Re: NSTAR Electric Company, D.T.E. 06-40

Responses to Information Requests

D.T.E. 06-40 Attachment DTE-4-4

Points of Demarcation between
Transmission and Distribution
Classified Facilities

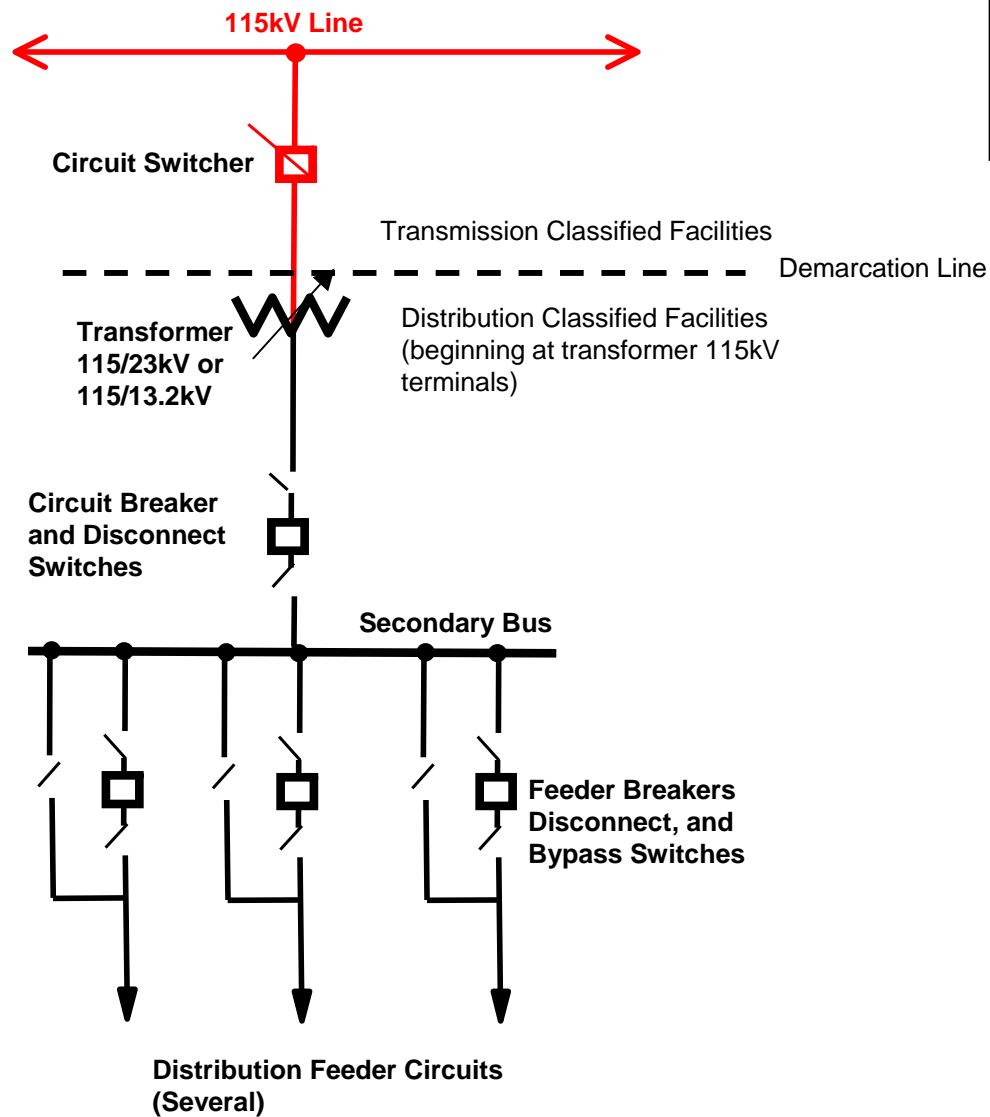
Refer to D.P.U./ D.T.E 97-93, at 6 (1997). According to this Order, Boston Edison considers facilities which convert transmission voltage to distribution voltage, such as its 115/14 kV and 115/24 kV substations, as distribution facilities. Please clarify whether all 115/14 kV and 115/24 kV transformers and 115 kV facilities at these stations for Cambridge and Commonwealth will be reclassified as distribution facilities. As part of this response, provide the demarcation line between transmission and distribution facilities at these substations.

Commonwealth classifies facilities at the 115/23 kV and 115/13.2 kV substations that operate at the 13.2 kV/23 kV level as distribution facilities. Those facilities that operate at the 115 kV level are classified as transmission. The step-down transformers that are rated at 115/23 kV and 115/13.2 kV operate at their respective lower voltage levels and are classified as distribution; thus, no reclassification of these facilities is needed. The point of demarcation between transmission and distribution facilities is on the line section between the 115 kV circuit switcher (an isolation and switching device) and the 115 kV terminals of the substation transformer, as shown in the Attachment DTE-4-4.
